#### PLANNING DEPARTMENT

VAR-01063-2015 and SIGN-01062-2015

Whizin Market Square (28888-28914 Roadside Drive)

Request for a Sign Permit for a Sign Program Amendment to install tenant, monument and directory signage in Whizin Market Square; and a Variance from Zoning Ordinance Section 9655.5.F.2.(i) to allow three monument signs (M1, M2 and M3) and three (3) directory signs (D1, D2 and D7) to be located less than five feet from the public right-of-way; Section 9655.5.F.2.(ii) to allow for one monument sign (M4) to exceed the maximum size area of 48 square feet; Section 9655.5.F.2.(iii) to allow three monument signs (M1, M2, M3, and M4) to exceed the maximum height of six feet; Section 9655.8.B.1.(a) to allow for a second, wall-mounted business sign (W5e) instead of one business sign for Plata Restaurant; Section 9655.8.B.1.(d) to allow four monument complex identification signs (M1, M2, M3 and M4) instead of one complex monument identification sign per street frontage; and Section 9655.8.B.1.(1) to install two directional signs (D3a and D3b) above three feet in height, and five (5) directional signs (D1, D2, D3a, D3b, and D7) in excess of three (3) square feet in size: and a requ

## Monument Sign M1 Photo-composite & Rendering

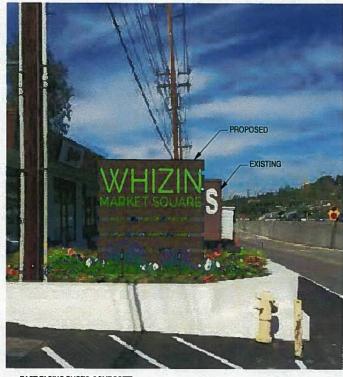
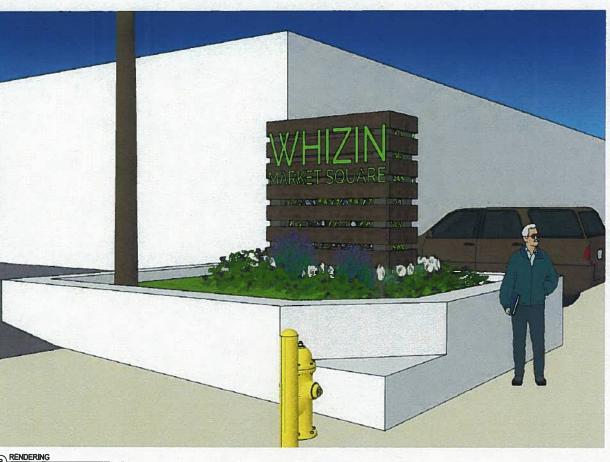
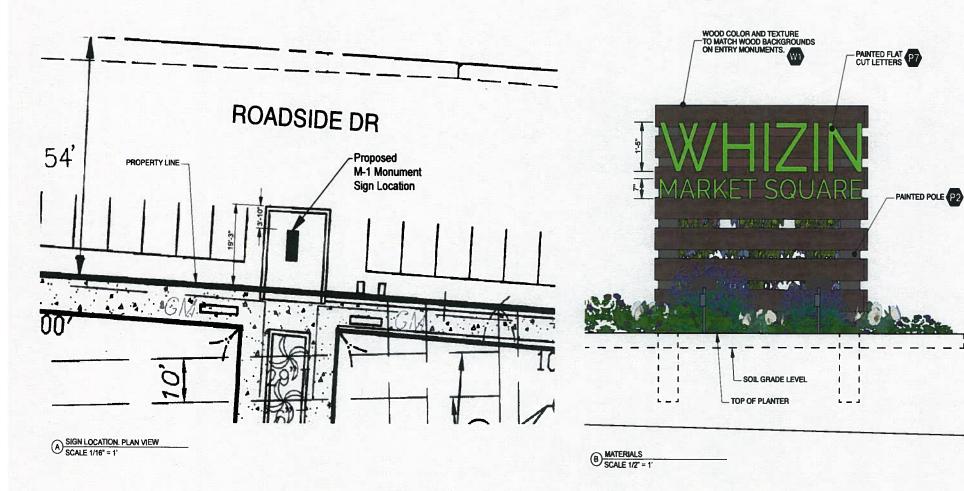
The proposed height of monument sign M1 itself is 6'6", but the height is measured from the grade elevation at a distance of five feet around the perimeter of the sign. Because of the narrow dimensions of the planter in which the sign is to be located, the proposed 9'5" height of the height of the monument sign includes the 2'11" high raised planter. With the proposed location within the planter to be approved by the Public Works Department, as conditioned, and the fact that the sign is proposed to serve as a replacement to the existing monument sign situated in the same raised planter, staff finds the proposed height of the sign to be appropriate for the identification of the Center from Roadside Drive, and the sign appropriately designed to match the architectural theme of Whizin Market Square.

- D. Monument Sign M1: The applicant shall relocate the sign, at their sole cost, a minimum of 6-feet back towards the buildings from its current location. The landscaping inside the planter box shall be kept low, and maintained to not exceed a maximum height of the outer boundary retaining curb face of the planter box.

## Monument Directory Sign - M2 Location & Photo-composites

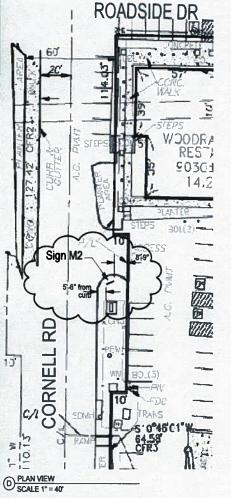
Staff recommends the Planning Commission deny the applicant's request for monument directory sign M2, which is proposed to be located in the public right-of-way. There is sufficient space within the on-site parking lot fronting Cornell Road to provide for a monument sign located at least five (5) feet from the property line, in compliance with the Zoning Ordinance. A new monument sign (Sign M3) is proposed in the same vicinity as the subject monument sign, at the south end of the parking lot fronting Cornell Road, and is proposed to serve the same purpose as monument sign M2 in attracting motorists utilizing the on-site parking lot. Also, a pedestrian directory sign is proposed at the east side of the parking for pedestrians entering the Center. Thus, this subject third sign (M2), proposed to be located in the same vicinity as two other directory signs. would be unnecessary for both motorists and pedestrians. In addition, the proposed monument sign (M2) within the public right-of-way will not allow for necessary visibility for motorists to safely enter and exit the north driveway of the parking lot fronting Cornell Road. One of the purposes of the Sign Ordinance is to reduce possible traffic and safety hazards by prohibiting signs that are distracting to motorists. The proposed monument sign is unnecessary to meet the identification needs of the Center and will not enhance the quality of visual environment of the City. A draft Resolution of denial for this particular monument directory sign is attached for the Planning Commission's consideration.

- A. The proposed sign program amendment for Sign M2 of the proposed Sign Program for the Center, is inconsistent with the General Plan and the provisions of the Zoning Ordinance, including the Sign Ordinance. Monument Sign M2, by being located in the public-right-of-way, would detract from the character of the retail center and would serve as a distraction to motorists traveling on Cornell Road.

#### Monument Directory Sign - M4 **Location & Photo-composites**

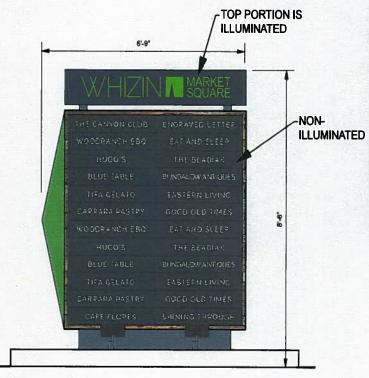
One monument sign (M4) would is proposed to be located within the interior parking lot on the east end of the Center. This directory monument sign is proposed to be positioned within a landscape planter along the main drive aisle of the parking area, accessed from Agoura Road.

- 4. The granting of the variance, as conditioned, will not be detrimental to the public health, safety, or welfare, or materially injurious to properties or improvements in the vicinity. The height of Sign M4 will allow for proper visibility of the Center for motorists and is located such that it will not conflict with traffic or pedestrian movement within the parking lot. The construction of the sign will meet City Building Code requirements and the proposed illumination will provide for adequate visibility without negatively impacting views from surrounding roadways or properties.

# Directional Sign - D1 Location & Photo-composite

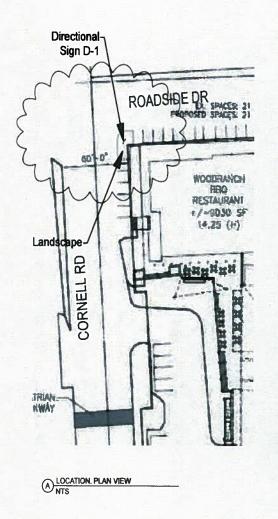
- 4. The granting of the variance, as conditioned, will not be detrimental to the public health, safety, or welfare, or materially injurious to properties or improvements in the vicinity. The location and size of Sign D1 will allow for proper visibility of the Center for motorists and are located such that it will not conflict with traffic or pedestrian movement. The sign's placement will provide for adequate visibility without negatively impacting views from surrounding roadways or properties.

- F. <u>Directional Sign D1</u>: This sign is subject to the requirements of Condition Nos. 8.A, 8.B and 8.C. above.
- G. <u>Directional Signs D2 and D7</u>: This sign is subject to the requirements of Condition Nos. 8.A, 8.B and 8.C. above. In addition, if this sign is located in the Los Angeles County Flood Control District right-of-way, the applicant shall provide written documentation to the City showing their approval of the sign location prior to any permit being issued for this particular sign.
